Rezoning Transportation Analysis

Petition Number: 2023-177

Date	Description
1-24-24	First Review (IW)

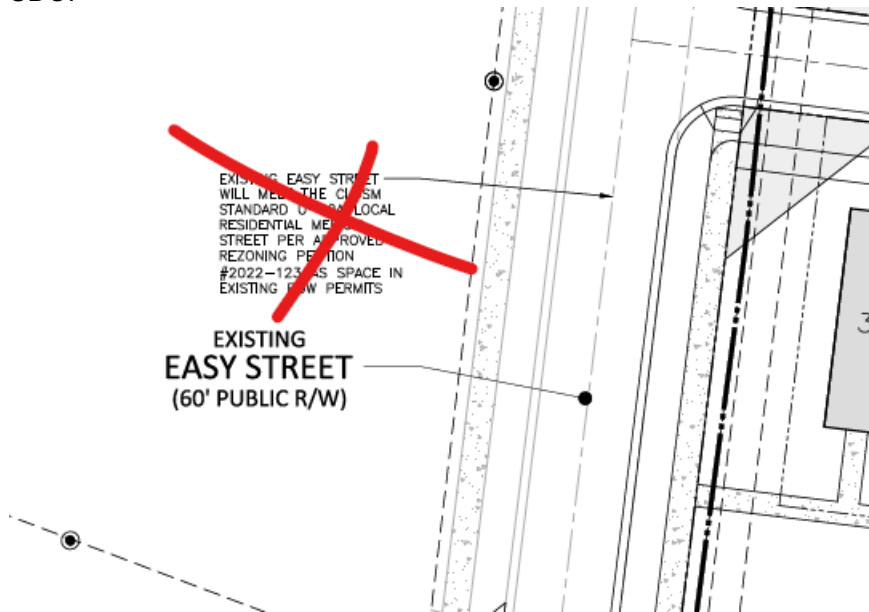
6. Revise site plan and conditional note(s) to update conditional note 3.e. and commit to building Easy Street to a Local Residential Wide Street (CLDSM U-03A2) along site frontage per UDO Article 32 requirement(s).

e. The Petitioner shall upgrade existing Easy Street to meet the CLDSM Standard U-02.

7. Revise site plan and conditional note(s) to remove labeling related to building Easy Street to a Residential medium standard, as the referenced previously approved rezoning was prior to the new UDO.

8. Revise site plan and conditional note(s) to either remove Conditional note 3.g. OR specifically list how site will be phased and what transportation improvements will be associated with each phase. CDOT will then determine if the request to phase improvements are agreeable.

~~g. Site will be developed in multiple phases. All transportation improvements that are the responsibility of the Petitioner, per phase in accordance with the Ordinance, shall be approved and constructed prior to the issuance of the first certificate of occupancy and subject to the Petitioner's ability to post a bond for any improvements not in place at the time of the issuance of the first certificate of occupancy.~~
